DEVELOPMENT SERVICES DEPARTMENT

DESIGN REVIEW REPORT AND DECISION

File Number: DSRFY2024 - 0014

Review Status: INITIAL REVIEW- NOT APPROVED

Figure 1: Measurement between Dutch Bros property and proposed Starbucks location.

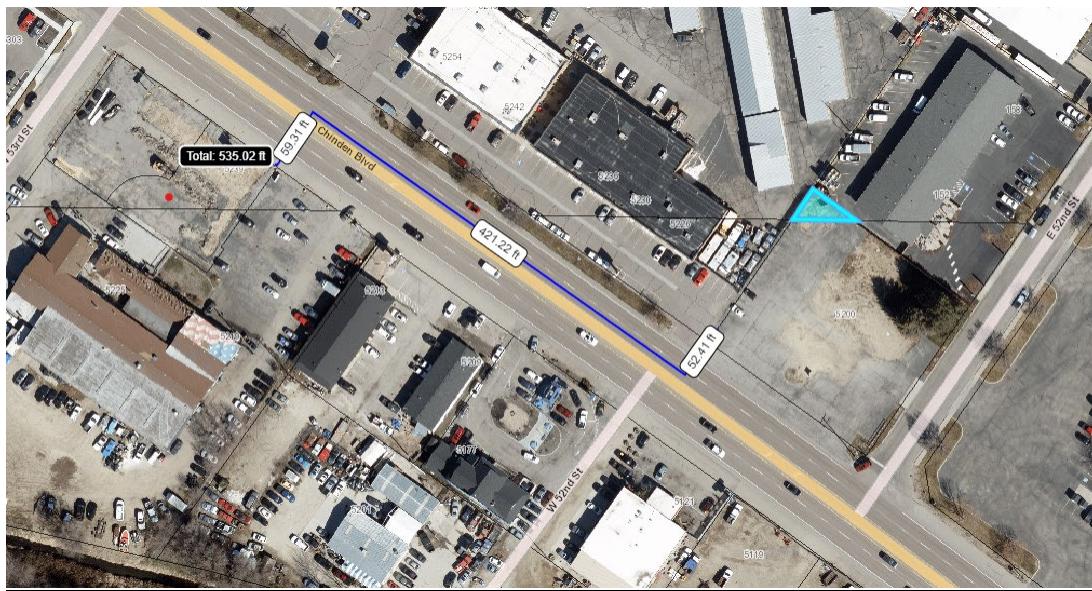
Per GCC 8-2C-13.3, "A drive-through establishment shall not be closer than five hundred feet (500'), as measured by the shortest unobstructed driving route from another drive-through establishment, except where access to the drive-through is provided by internal circulation within a commercial site and would not create an additional curb cut to the arterial roadway".

Although the code describes measurement by shortest unobstructed driving route, further discussion should be had regarding the method of measurement. Furthermore, code does not specify if the restriction applies to establishments on the same side of the road or on an opposite side of the road. Staff has measured the route between the existing Dutch Bros at 5239 W. Chinden and the proposed Starbucks location and have interpreted this measurement as being compliant with code, but only if measurements are taken as a vehicle would drive [\(Image 1\)](#). This measurement is from property edge to property edge, measurements were not taken from existing Dutch Bros access and proposed Starbucks access.

An alternative measurement route that would make the application not compliant with code would be to draw a direct line from the nearest property corners, however, staff does not believe that way of measurement meets the intent of code.

(See included map and measurements)
